Informal document GRSP-54-07-Rev.1
(54th GRSP, 17 – 20 December 2013,
-agenda item 3(b))

**Proposal for Amendment [x] to global technical regulation
No. 9 (Pedestrian safety)**

**Proposal of further amendments to document
GRSP-54-07-Rev1,
Submitted by [xxx]**

Figure 5A: Corner of bumper (see paragraph 3.134.)

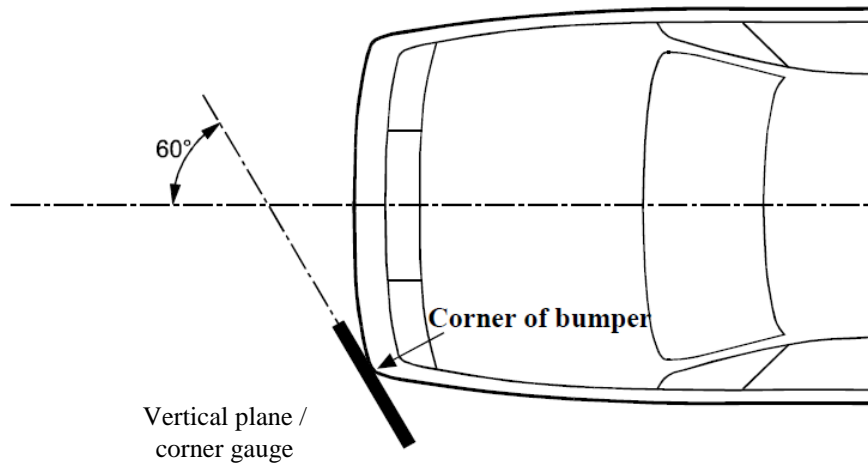
3.14. "Corner of bumper" means ~~the vehicle's point of contact with a vertical plane which makes an angle of 60° with the vertical longitudinal plane of the car and is tangential to the outer surface of the bumper (see Figure 5).~~ **a point on the outer surface of the bumper. The transversal position of the corner of bumper is determined in accordance with either paragraph 3.14.1 or paragraph 3.14.2, whichever is more outboard.**

3.14.1. **The transversal position of the corner of bumper is determined as the vehicle's point of contact with a vertical plane which makes an angle of 60° with the vertical longitudinal plane of the car and is tangential to the outer surface of the bumper (see Figure 5A).**

Figure 5B: Corner Gauge

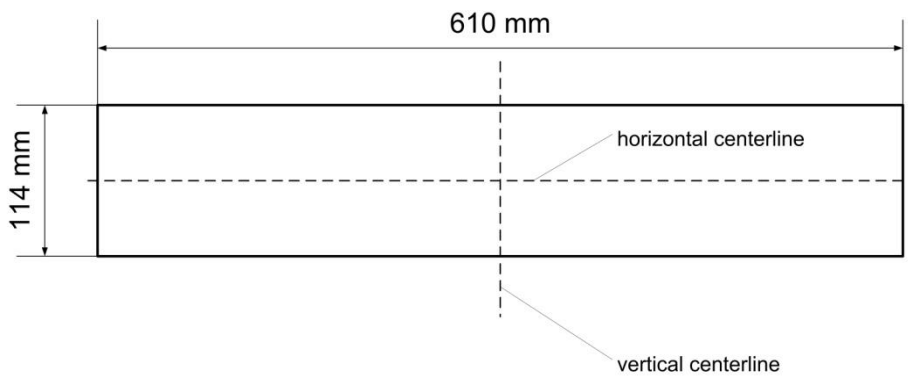
3.14.2. **The transversal position of the corner of bumper is determined with a corner gauge as defined in Figure 5B.**

The front surface of the corner gauge is flat

Figure 5C: Determination of Corner of Bumper with corner gauge

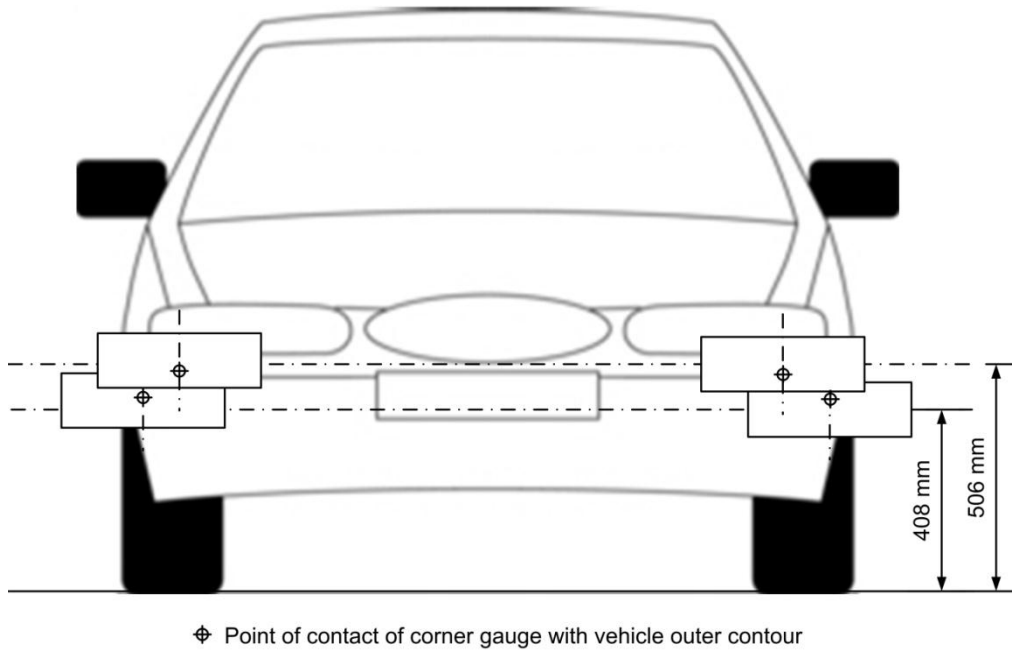
For determination of the corner of bumper the front surface of the corner gauge is moved parallel to a vertical plane with an angle of 60° to the vertical longitudinal centre plane of the vehicle (see Figures 5A and 5C) at heights of the horizontal centre line of the corner gauge at 408 mm and 506 mm above the ground reference plane.

For determination of the corner of bumper the gauge is moved to contact the outer contour of the vehicle touching at the vertical centreline of the gauge.

The corner of bumper is defined as the most outboard point of contact of the gauge with the outer contour of the vehicle according to this procedure.
